CENTERVILLE CITY PLANNING COMMISSION AGENDA

PLANNING COMMISSION MINUTES OF MEETING

PDO CONCEPTUAL PLAN ACCEPTANCE FOR A MASTER PLANNED MIXED-USE PROJECT:

APPLICATION: CONCEPTUAL SITE PLAN APPROVAL FOR
BAMBERGER OFFICE BUILDING

Sheet Title
Architectural
Site Plan

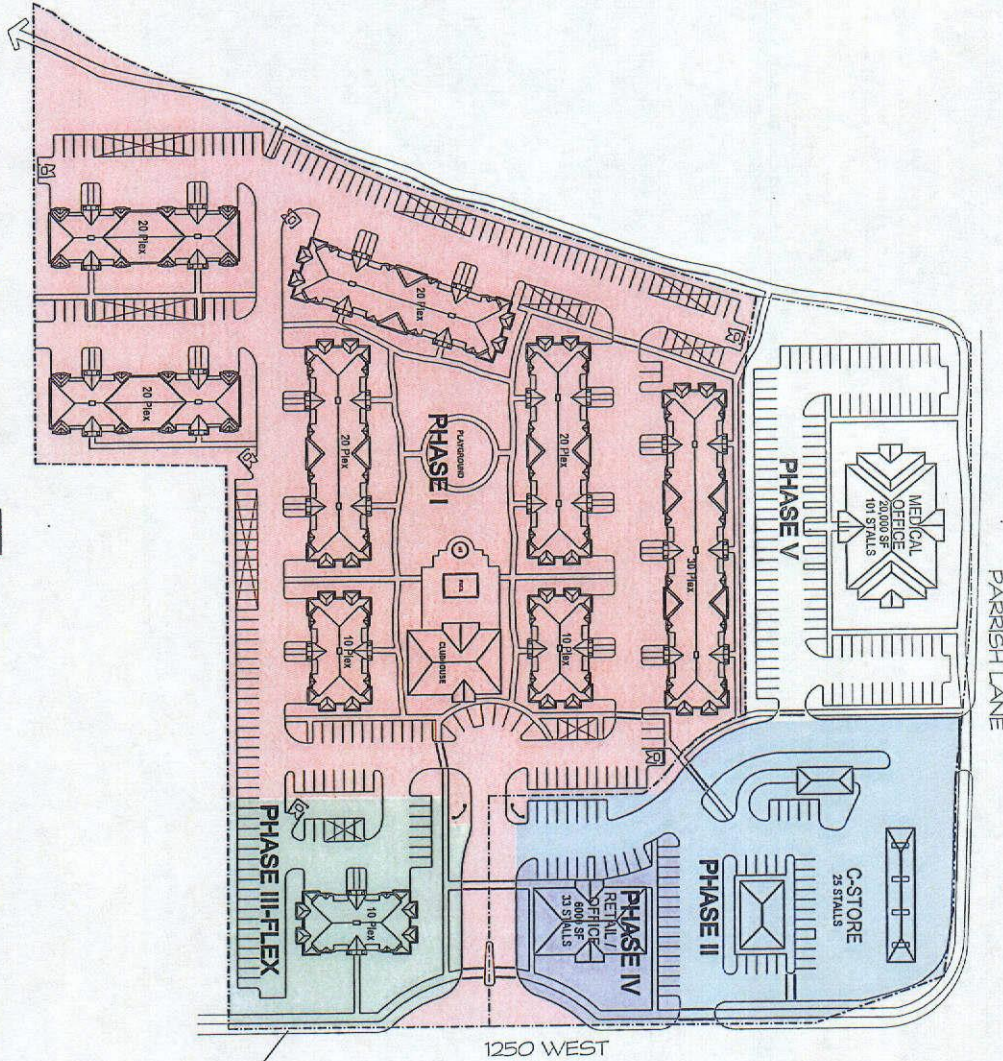
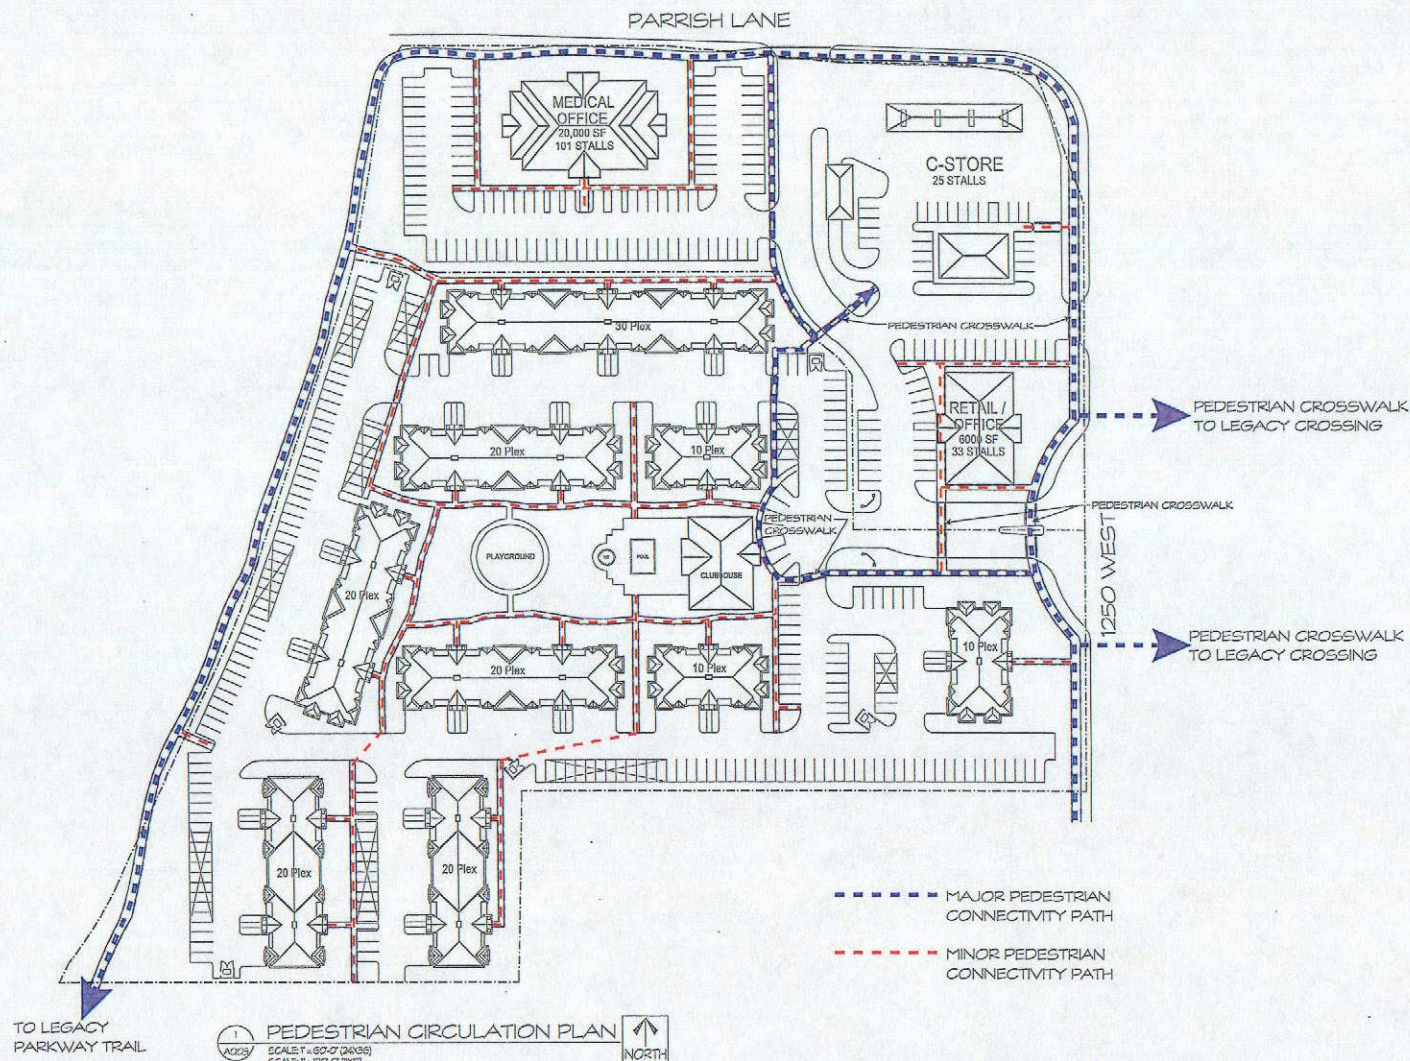
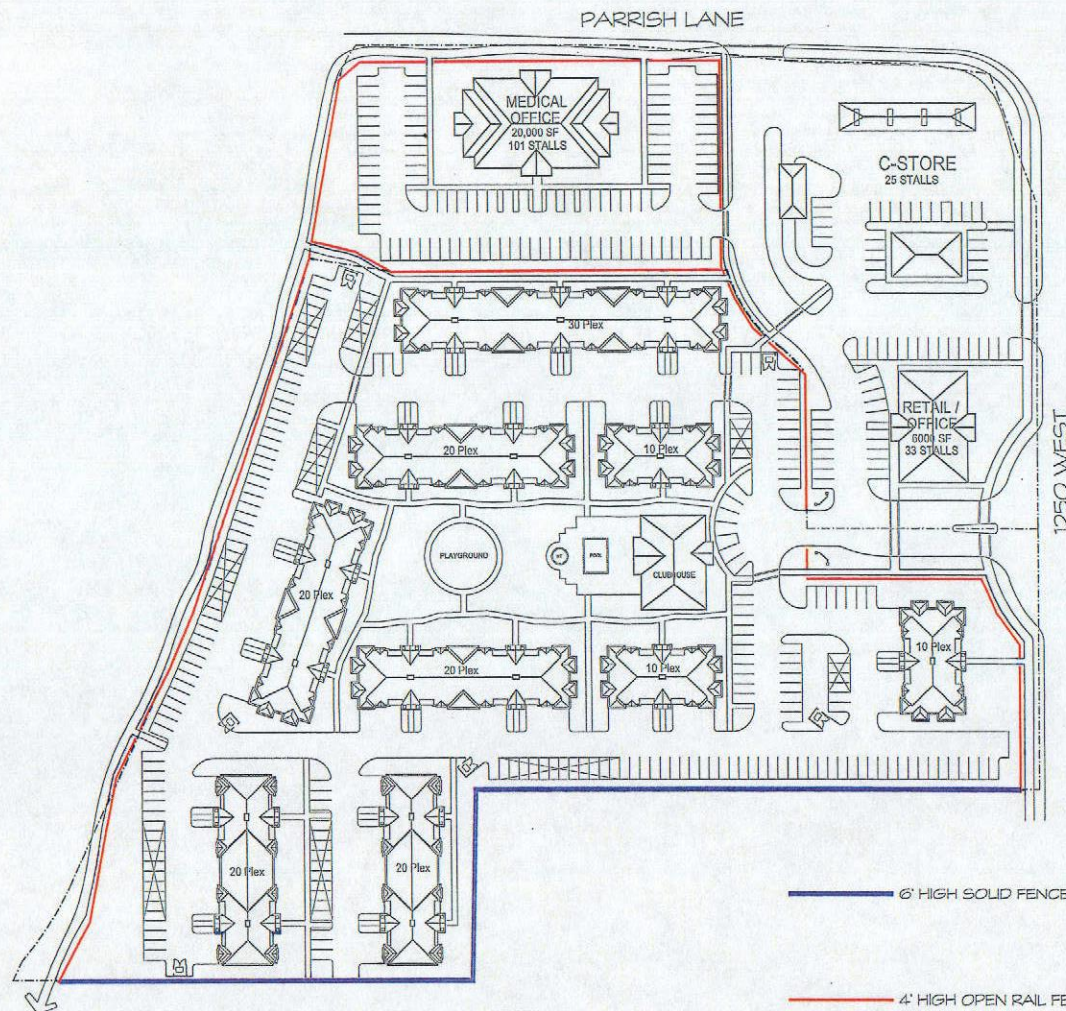
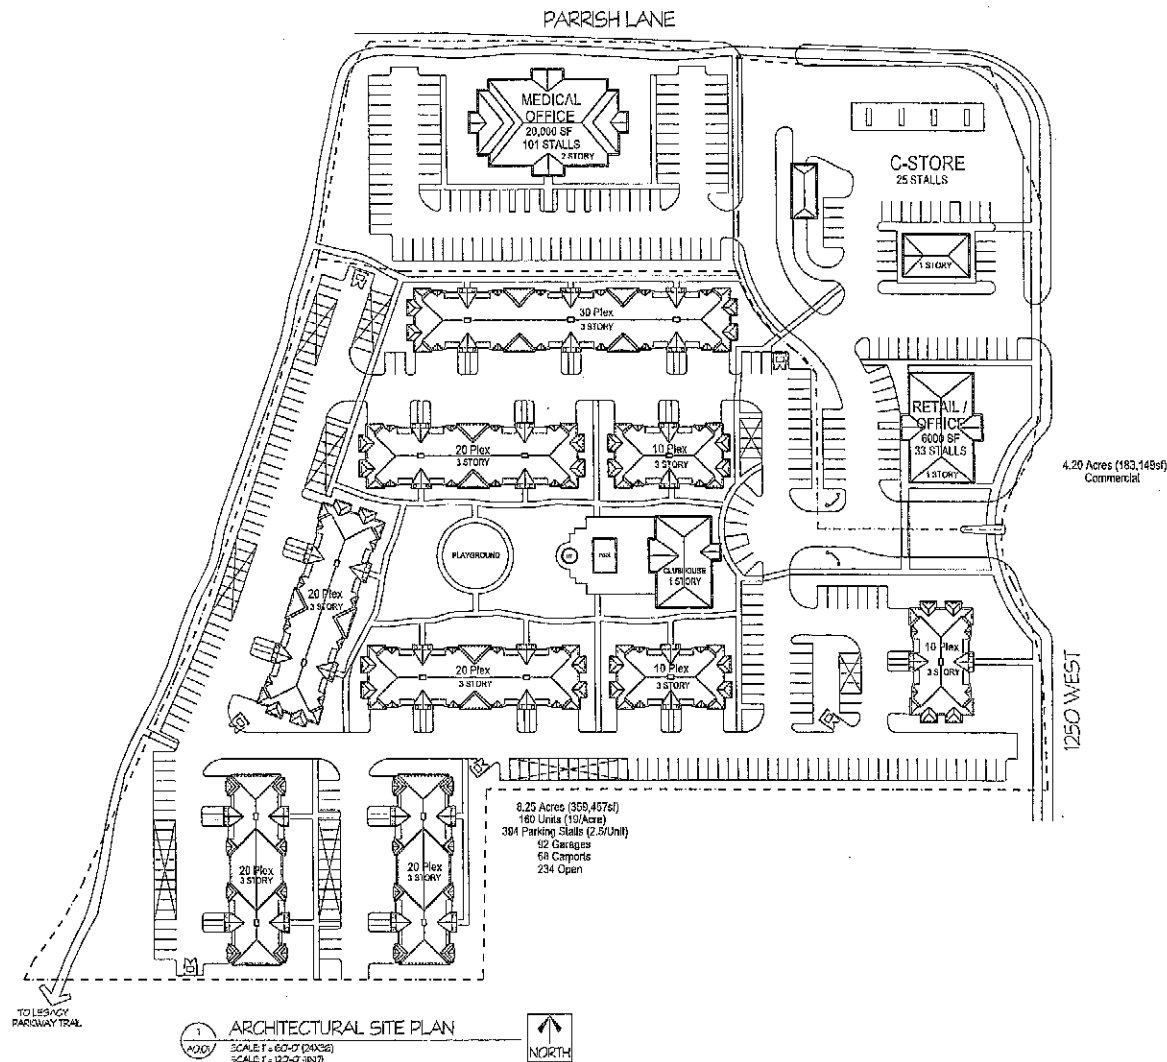
- g. At least one (1) exhibit must be revised to include the conceptual building and parking lot layouts and provide dimensional marks and references to better depict the expected minimum distances that are to be used in future site plan, subdivision, and building permit checks and approvals.

Staff Response: The architect is preparing a dimensional plan for the project and it will be available for Commission review at the meeting.

A PRELIMINARY NORTH ELEVATION (Bamberger Way Entrance)
1/8"=1'-0"

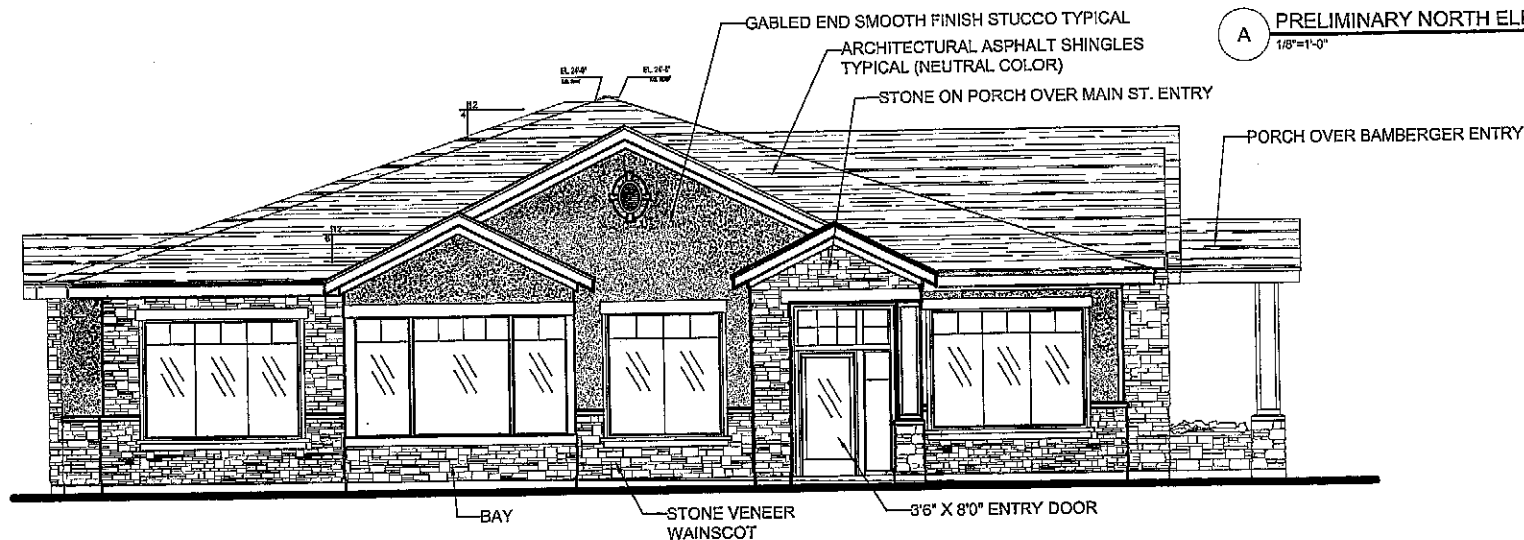
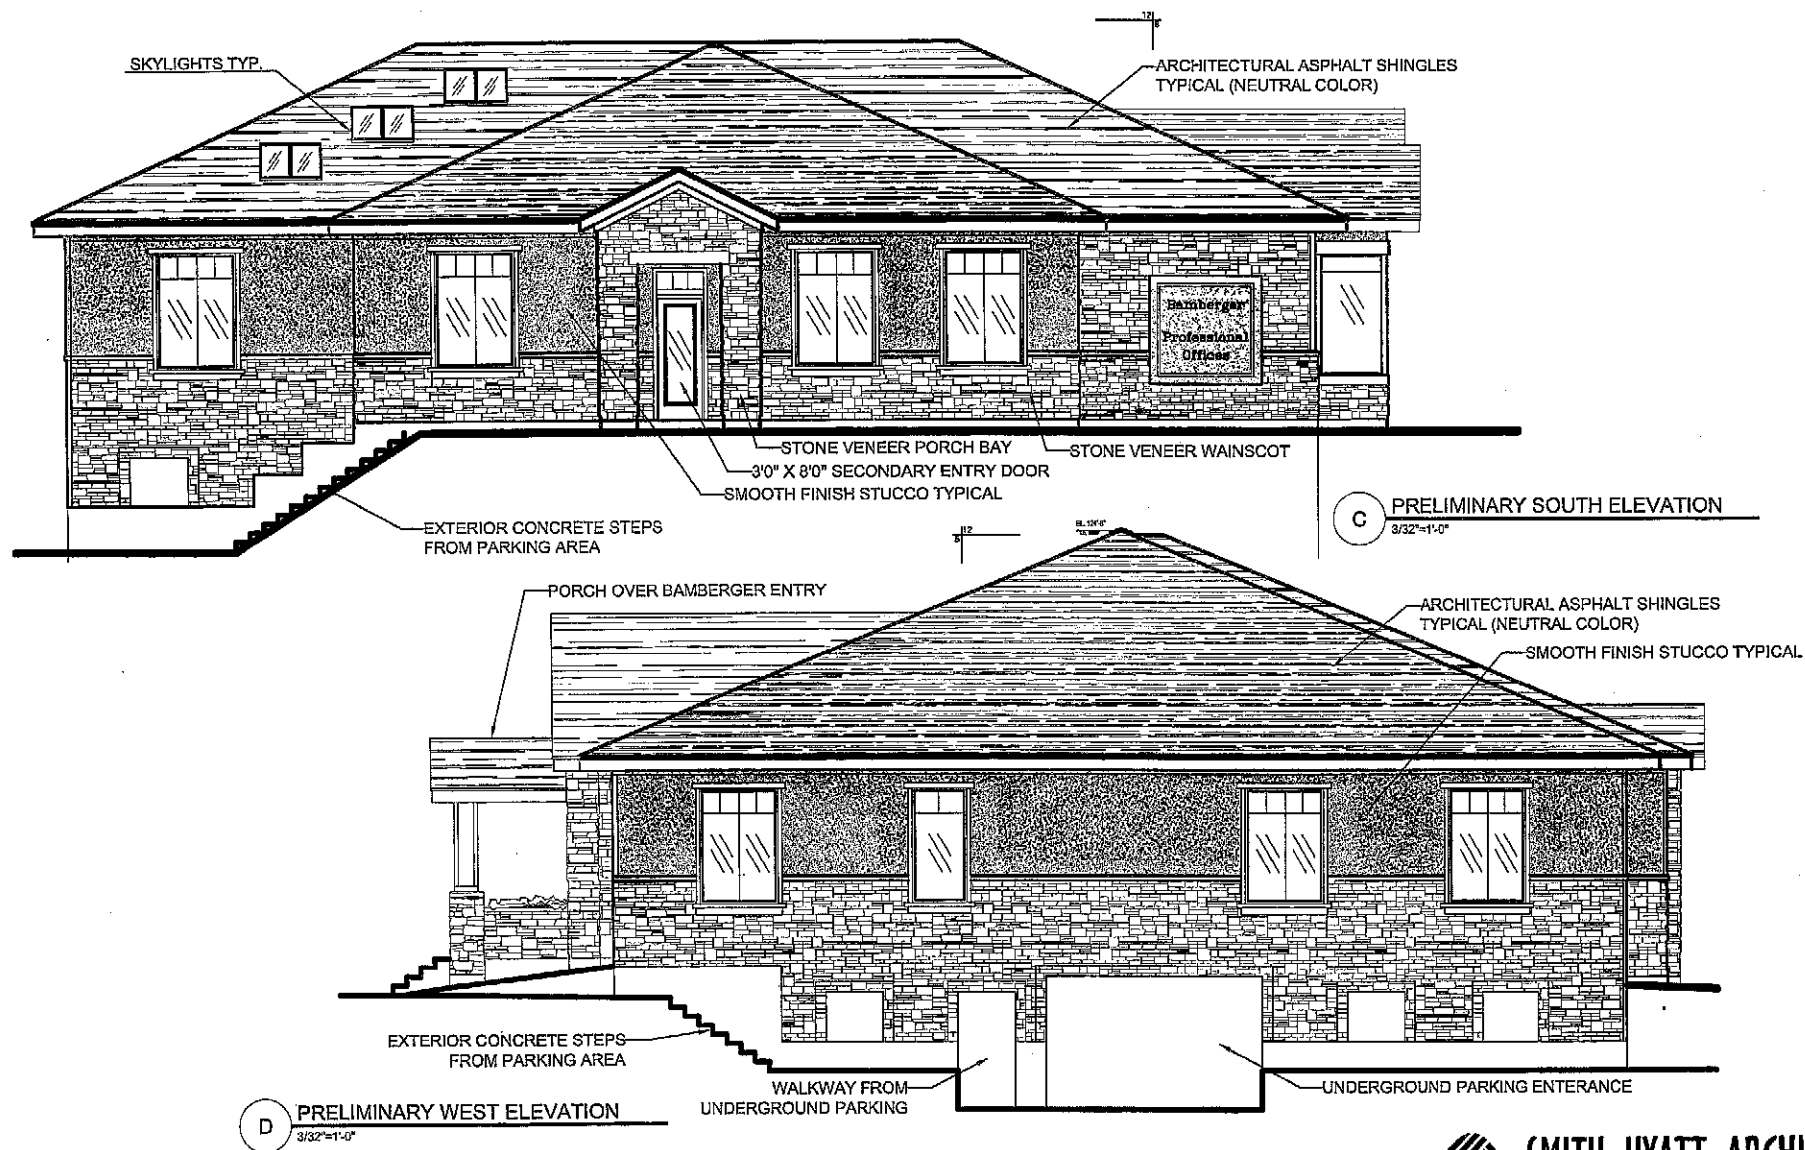
4. At least 15% of a secondary façade facing another non-primary street frontage shall be of upgraded architectural features.

The Bamberger Way Elevation, where the entry to the second suite to the building is located, has been accented with multiple stone covered bays with gable end roofs to break the length of the wall along the street, and a covered porch with raised wood columns extends over the entry. In addition large oversized window are used to break the wall spaces. (See North Elevation A)

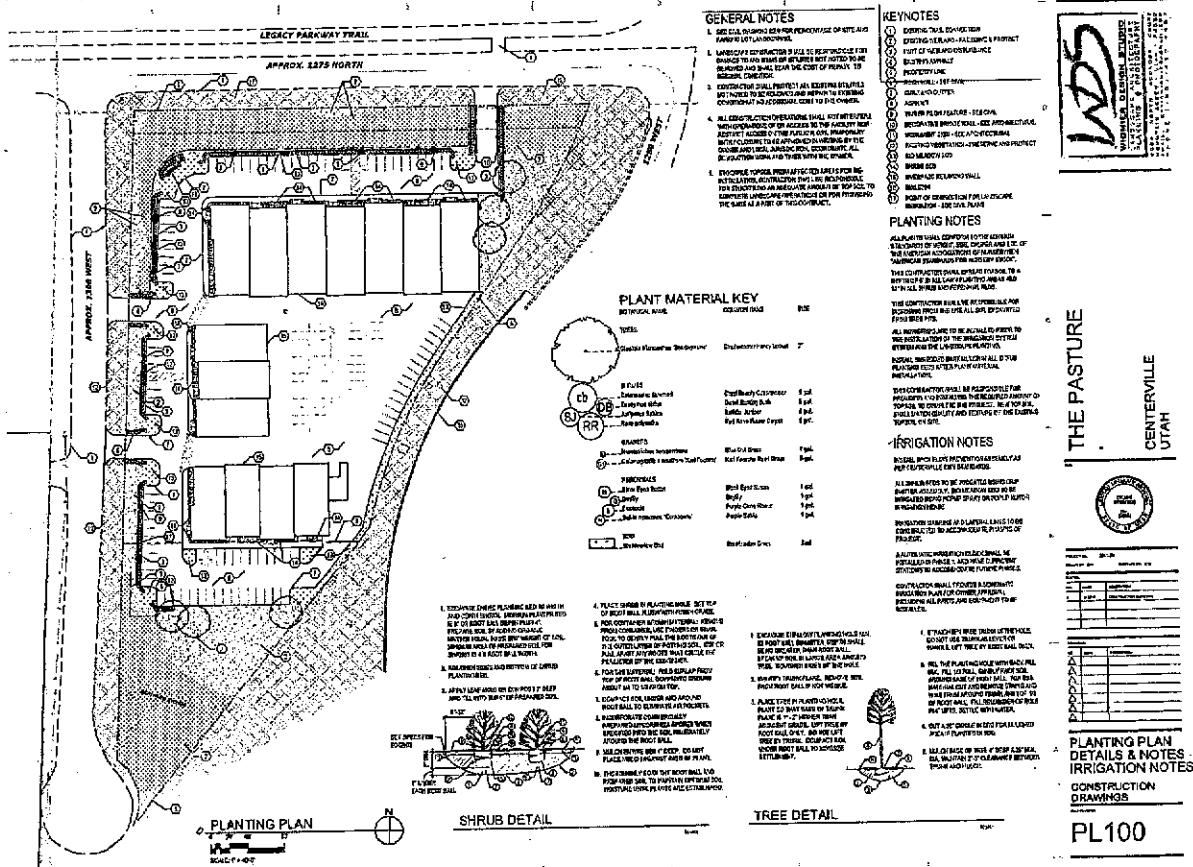
- **Staff Concern:** Within Chapter 12-68, Shorelands Commerce Park District Design Standards, it is clear to how this wall should be designed. It first states in Section 12-68-040(e), that man-made accents are allowed such as terraced walls with limited height. This gives the impression that solid long walls are not the ideal choice of retention. In Section 12-68-050(c)(1), it states that structures and exterior spaces blend into the natural contours of the site. Furthermore, in this same section, it also states that man-made contouring match natural contouring, and to not start and stop with abrupt edges. Finally, in Section 12-68-050(d)(10), it requires walls and all landscaping features to be used in a natural appearing manner.

Staff does not see the current wall meeting this requirement. However, the wall in its similar construction was approved by the Planning Commission on April 25, 2012, with the wall being broken up by the timber landscaping design feature. Therefore, in order for staff to meet the intent of the original approval and the requirements found in Chapter 12-68 of the Zoning Ordinance, staff is requesting the timber accents be placed below the wall and as close to the wall as possible. In addition, the Shorelands Commerce Park SCP) approved vegetation needs to be planted around the timbers in order to give the appearance from the street that these spaces are broken up. Staff also requests that these features and plantings have a random and not a formalized appearance, therefore meeting the Ordinance requirement of a natural and complementary shoreland environment. Finally, around the corners of the wall and especially the sign area, staff requests these areas have more of a natural curve and have some rocks removed and placed at a 45 degree angle and with SCP vegetation planted around this area. This landscaping detail will need to be submitted as part of the final amended site plan.

1. The applicant shall submit an amended final site plan, meeting the standards found in Section 12-21-110(e) of the Ordinance.
2. The applicant shall address the timber concept and indicate location and height over the rock wall and plantings appropriate to the Shorelands Commerce Park Design.
3. The timbers and landscaping shall be placed as to appear random and natural, rather than formalized.
